Planning Commission Vote Report

Subject: Rezoning Vote Report

Petition: P.Z. 14-2013 St. Luke's Hospital-West Campus (175 S. Woods

RE: P.Z. 14-2013 ST. LUKE'S HOSPITAL – WEST CAMPUS

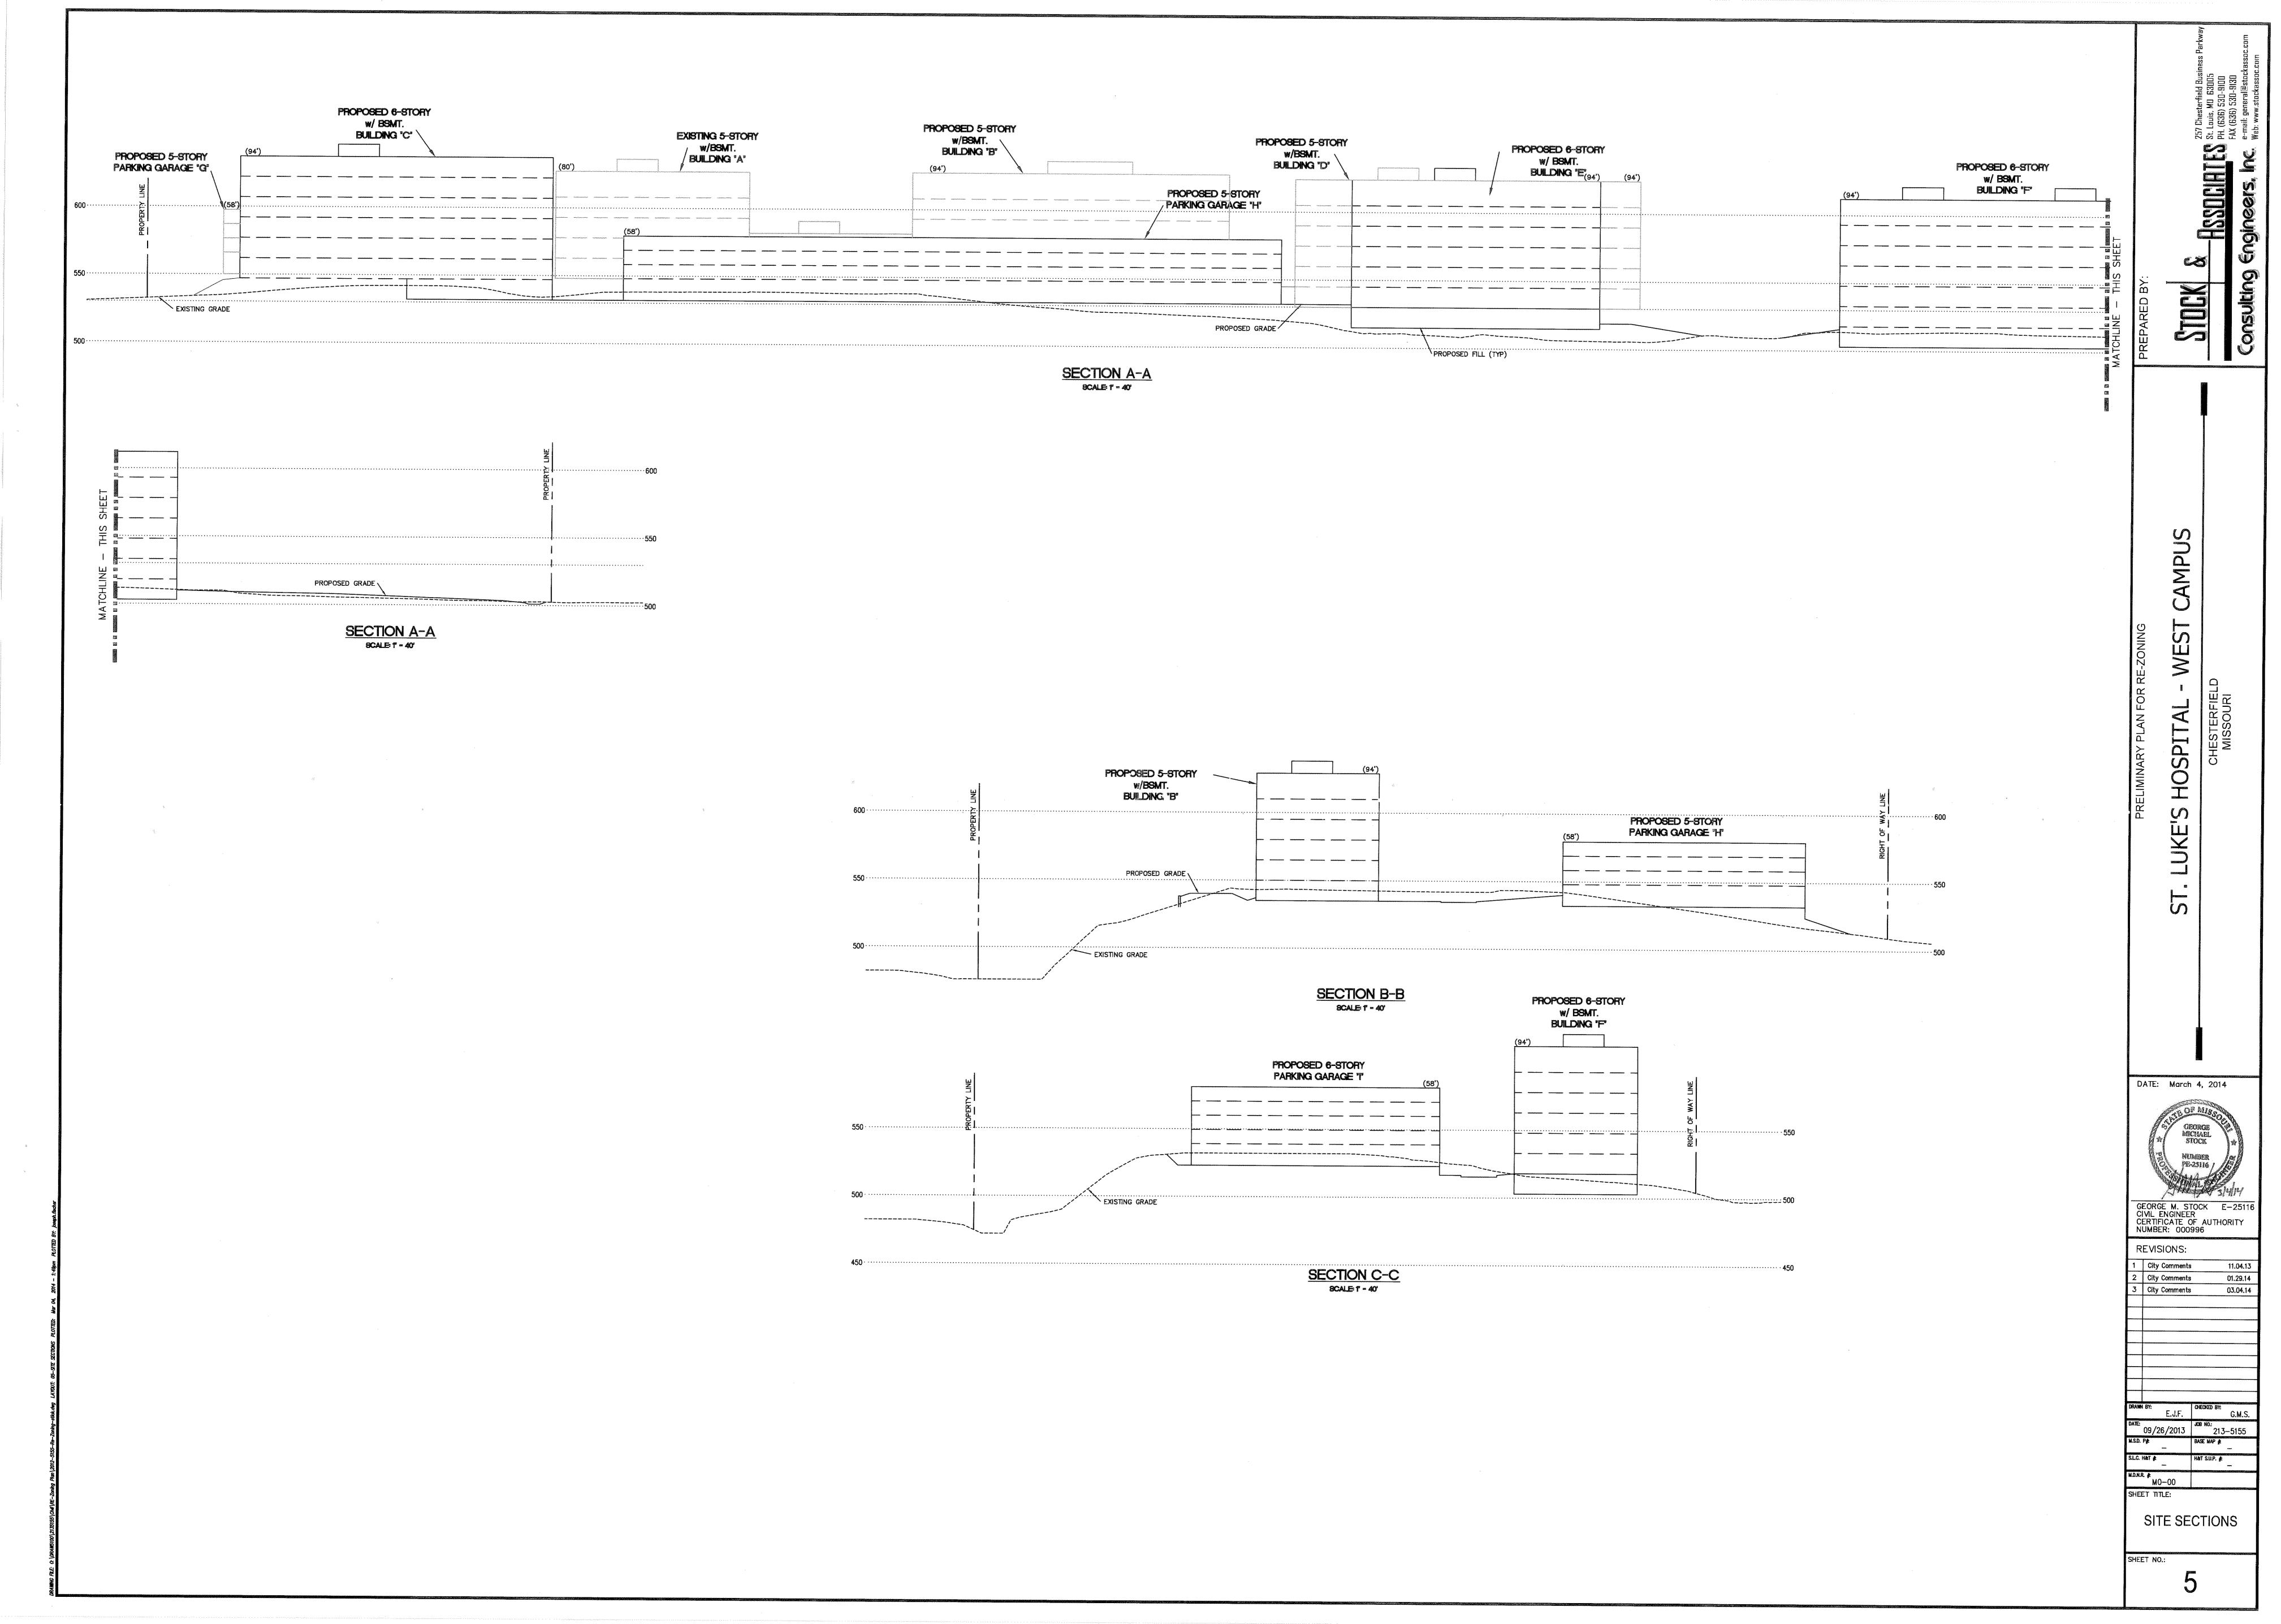
- 2. Correction of setbacks and landscape buffers on the Preliminary Plan as follows:
 - Depict the required 30 foot landscape buffer along the southern border of Parcel B.
 - While the previous ordinance permitted a 25 foot setback along the southern border of Parcel B, evaluate a 30 foot building setback to accommodate the 30 foot landscape buffer.
 - Identify the 30 foot landscape buffer along the east and north boundary of Parcel E.
 - The 25 foot building setback should be increased to accommodate this 30 foot landscape buffer on Parcel E. Amend the north setback to be 30 foot.
 - The east setback for Parcel E is 50 foot.

The Revised Plan shows the correct setbacks and landscape buffers.
